AMENDMENT OF SOLICITATION/MODIFICATION OF CONTRACT				1. CONTRACT ID CODE		PAGE OF PAGES	
				1		48	
2. AMENDMENT/MODIFICATION NO. A0001		3. EFFECTIVE DATE 17-Apr-2018		4. REQUISITION/PURCHASE REQ. NO.		5. PROJECT NO.(If applicable)

Herbert Hoover Dike Rehabilitation, Structure Replacement S-288 (HP-1) Reconstruction
Amendment 0001

SUMMARY OF CHANGES

S-288 (HP-1) RECONSTRUCTION
STRUCTURAL
STEEL COFFERDAM PLAN, ELEVATION AND DETAILS

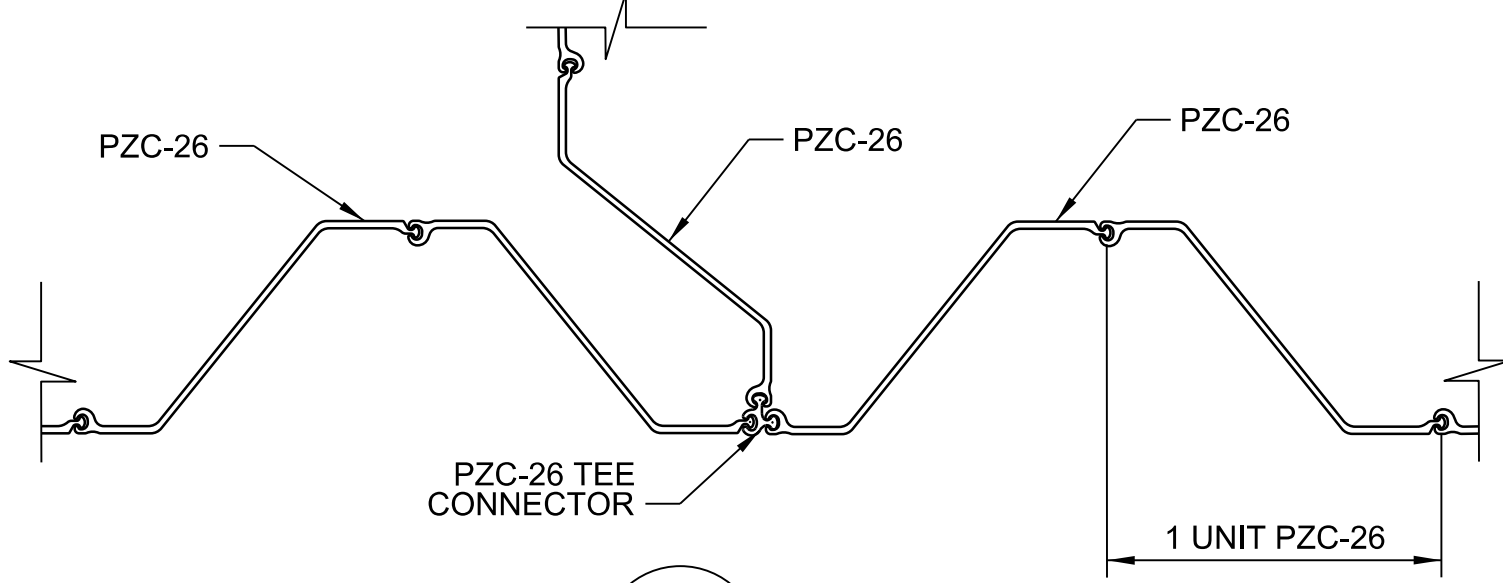
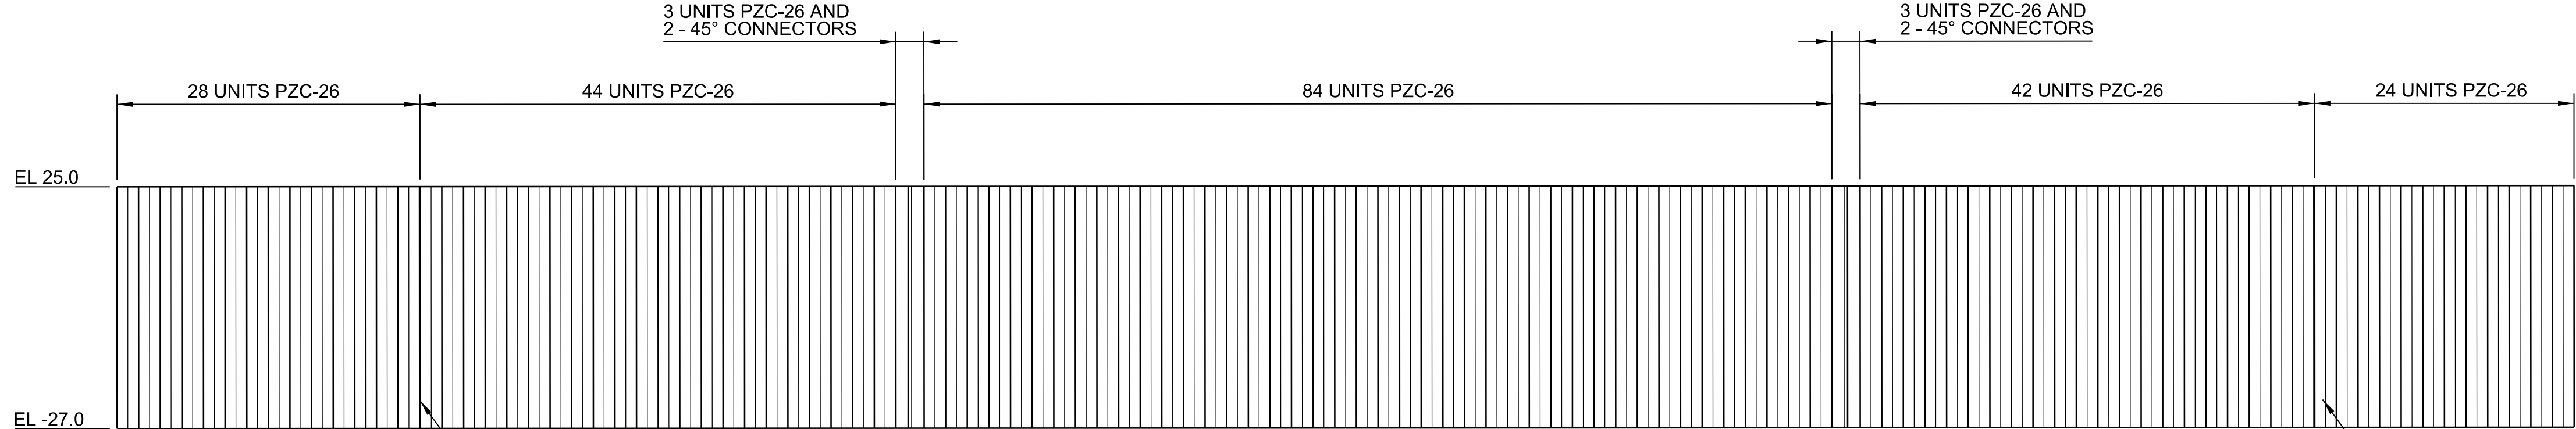
DELETE Drawing No. S-63 and **REPLACE** with the attached revised Drawing No. S-63.
